Access Compliance Report

Public Rights-of-Way

(Curb Ramps)

Intersection ID: 29139	Main Street: BALSAM_TREE_DR	Cross Street: STONEY_VALLEY_CT	Location: NW
ADA ID: 2F92E981E05B	Ramp Type: BlendTrans1	Initial Pass/Fail: Fail	Overall Compliance: No
Severity Score: 25			
Codes/Mitigation Info/Possible Solution		Field Measurements/Component Compliance

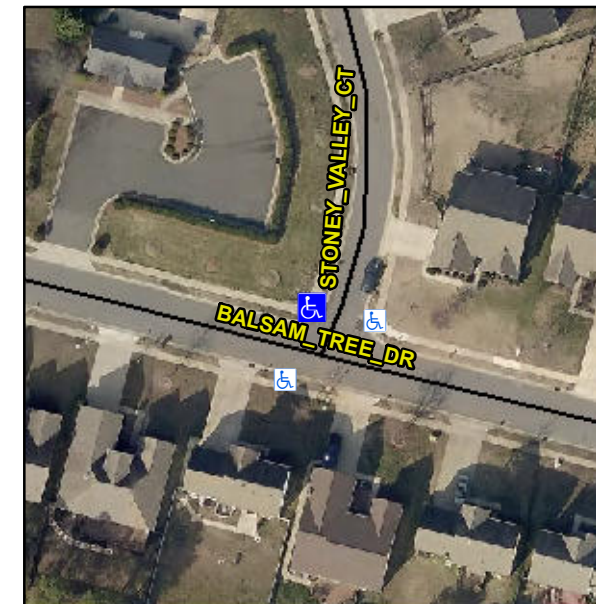
PROW/ADA:

Not Found, R304.5.3

Compliance	Description	Data	Compliance	Description	Data
N/A	Ramp Length (in)	49.0	Yes	BlendTrans Slope (%)	0.1
Yes	Ramp Width (in)	224.0	No	BlendTrans XSlope (%)	10.6
N/A	Flare Type LT	N/A	N/A	Flare Type RT	N/A
N/A	Flare Slope LT (%)	N/A	N/A	Flare Slope RT (%)	N/A
N/A	Flare Traversable LT?	N/A	N/A	Flare Traversable RT?	N/A
N/A	Landing Length (in)	N/A	N/A	DWS Provided?	N/A
N/A	Landing Width (in)	N/A	N/A	DWS Contrast?	N/A
N/A	Landing Slope (%)	N/A	N/A	DWS Length (in)	N/A
N/A	Landing X Slope (%)	N/A	N/A	DWS Full Width?	N/A
N/A	Landing Curb? (Y/N)	N/A	N/A	DWS Offset (in)	N/A
N/A	Shared Landing?	N/A			
N/A	Gutter Ponding?	N/A	N/A	Gutter Slope (%)	N/A
N/A	Gutter Lip Ht (in)	N/A	N/A	Gutter X Slope (%)	N/A
N/A	Painted X Walk1?	No	N/A	Painted X Walk2?	No
	X Walk 1 Direction	To SE		X Walk 2 Direction	To E
	X Walk 1 Width (in)	N/A		X Walk 2 Width (in)	N/A
	X Walk 1 Slope (%)	3.9		X Walk 2 Slope (%)	4.0
	X Walk 1 X Slope (%)	4.8		X Walk 2 X Slope (%)	5.1

N/A	Ramp inside XWalk1?	N/A	N/A	Ramp inside XWalk2?	N/A
	Road Slope (%)	5.3		Clear Space?	N/A
	Road X Slope (%)	0.7	N/A	Clear Space to XWalk (in)	N/A
N/A	Any Obstructions?	N/A	N/A	Storm Grate/Utility Hazard?	N/A
	Obstruction Type			Storm Grate/Utility Type	
		N/A			N/A
			Yes	Surface Condition? (G/P)	Good
			No	Curb Slope (%)	8.5

Possible Solutions:

Remove & Replace Curb Ramp With Two New Directional Ramps or Equivalent.
